# 20 SUB2007-00275

## MERTZ COURT SUBDIVISION RESUBDIVISION OF A PART OF LOT3

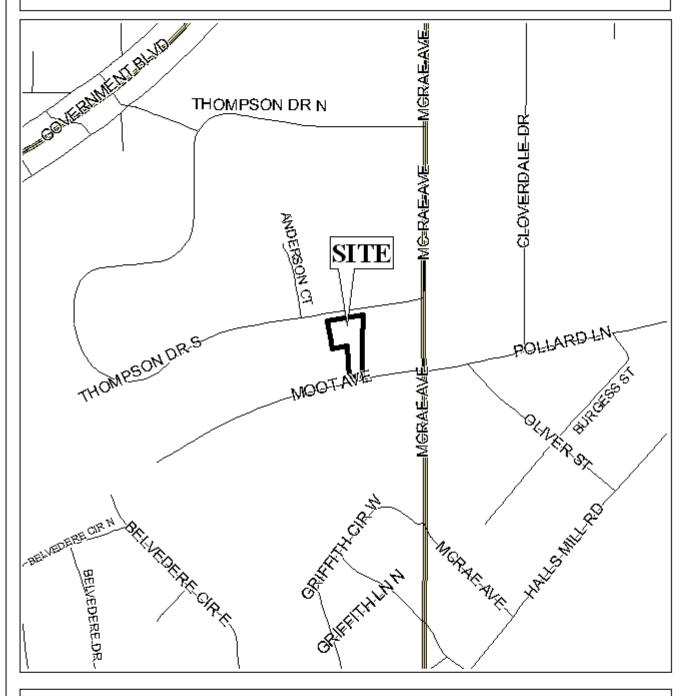
The plat illustrates the proposed  $0.6\pm$  acre, 3 lot subdivision, which is located on the North side of Moot Avenue, 255' $\pm$  West of McRae Avenue, extending to the South side of Thompson Drive South, in City Council District 4. The site is served by city water and sanitary facilities.

The purpose of this application is to create three lots of record from a metes and bounds portion of a legal lot. The excluded portion of the parent parcel appears to have been illegally subdivided in 1963, and typically it should be included in the subdivision process. However, due to multiple ownerships of the property, an exception would be appropriate.

The site fronts South Thompson Drive and Moot Avenue with 50' of right-of-way each. Since both are minor streets with curb and gutter, they are compliant with Section V.B.14. of the Subdivision Regulations, and no right-of-way dedication is required.

Lots 1 and 2 have approximately 80' of frontage each along South Thompson Drive, and Lot 3 has approximately 60' of frontage along Moot Avenue. As a means of access management, a note should be place on the final plat stating that Lots 1 and 2 are limited to one curb cut each to South Thompson Drive, and Lot 3 is limited to one curb cut to Moot Avenue, with the size, location, and design to be approved by Traffic Engineering and conform to AASHTO standards.

Based on the preceding, the application meets the minimum requirements of the Subdivision Regulations and is recommended for Tentative Approval, subject to the following conditions:

- 1) placement of a note on the final plat stating that Lots 1 and 2 are limited to one curb cut each to South Thompson Drive, and Lot 3 is limited to one curb to Moot Avenue, with the size, location, and design to be approved by Traffic Engineering and conform to AASHTO standards; and

- 2) subject to engineering comments: (It is the responsibility of the applicant to look up the site in the City of Mobile (COM) GIS system and verify if NWI wetlands are depicted on the site. If the COM GIS shows wetlands on the site, it is the responsibility of the applicant to confirm or deny the existence of wetlands on-site. If wetlands are present, they should be depicted on plans and/or plat, and no work/disturbance can be performed without a permit from the Corps of Engineers. Must comply with all storm water and flood control ordinances. Any work performed in the right of way will require a right of way permit.
